10: <b>SUPERSEDED BY EI 97-006          EFFECTIVE 9/25/97</b>	<b>ENGINEERING INSTRUCTION</b> NEW YORK STATE DEPARTMENT OF TRANSPORTATION
<b>Distribution:</b> 30 Main Office      32 Regions      34 Special	<b>Code:</b> <u>E. I. 92-10</u>
<b>APPROVED:</b>  <u>ARUN M. SHIRGALE, Deputy Chief Engineer (Structures)</u>	<b>Date:</b> <u>3/4/92</u> <b>Supersedes:</b>

**Subject:** MODIFICATIONS OF THE CURRENT SHEAR KEY AND TENDON SYSTEM  
FOR ADJACENT BEAM PRESTRESSED CONCRETE STRUCTURES.

BOX UNIT SHEAR KEY DETAIL

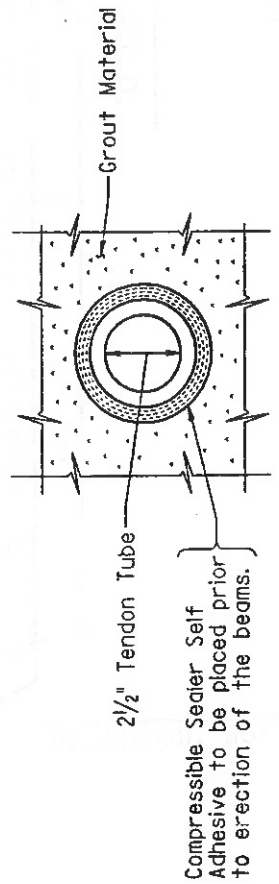
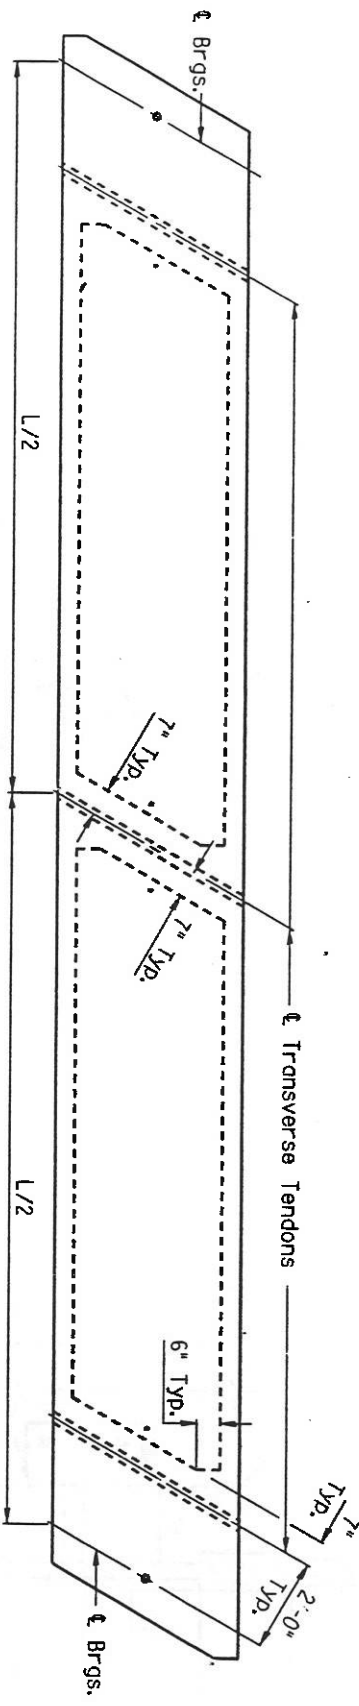
- 1.) The current shear key depth be increased. See Attachment No. 1.
- 2.) The number of tendons be increased and placed as follows: (See Attachment Nos. 2, 3, and 4)
  - A.) for span lengths less than 50', 1 tendon placed at the centerline of span, and 1 tendon placed at each end (approximately 2' from Centerline of Bearings) - three tendons total for spans less than 50'.
  - B.) for all spans greater than or equal to 50', 1 tendon placed at the centerline of span, 1 tendon placed at each quarter point, 1 tendon placed at each end (approximately 2' from Centerline of Bearings) - five tendons total for span lengths greater than or equal to 50'.

STAGE CONSTRUCTION (OPTION 1)

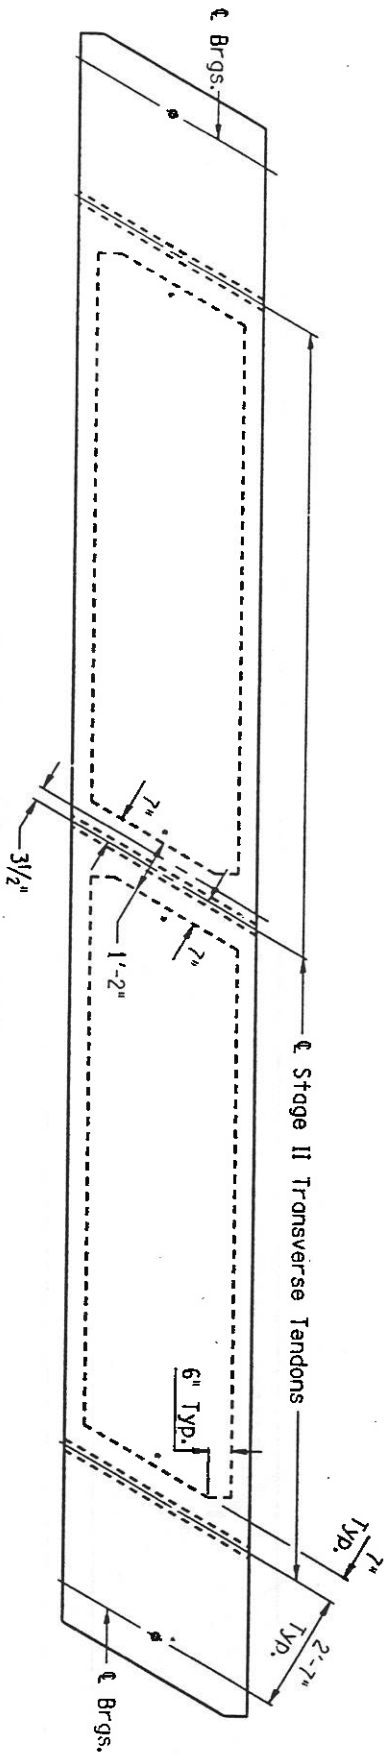
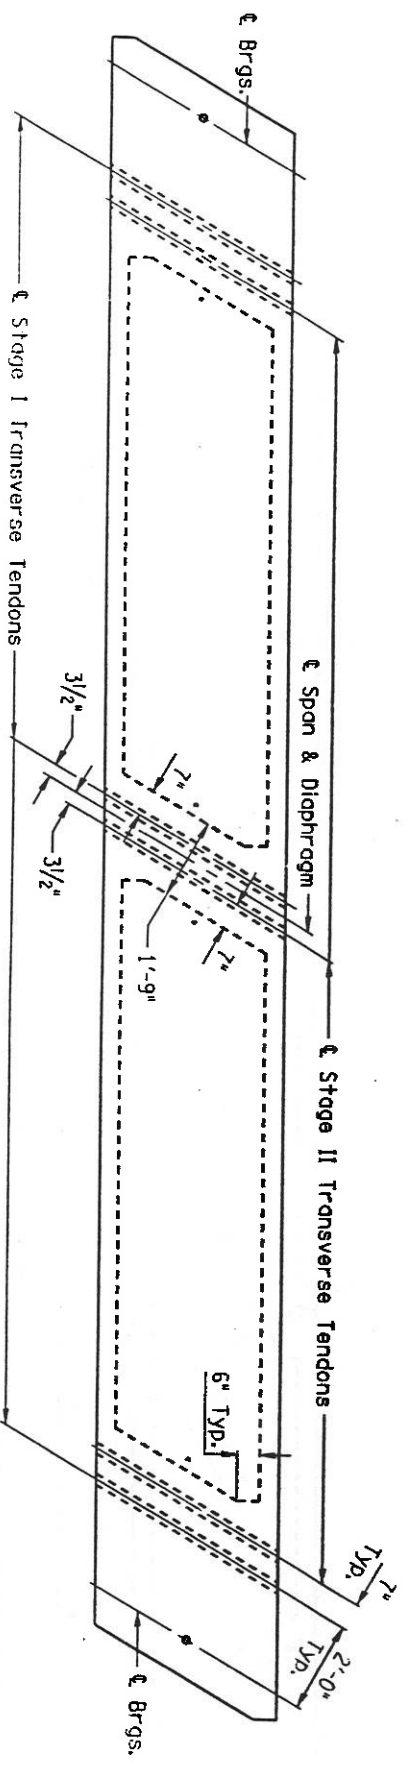
For Spans > 50'-0", Add quarter point tendons
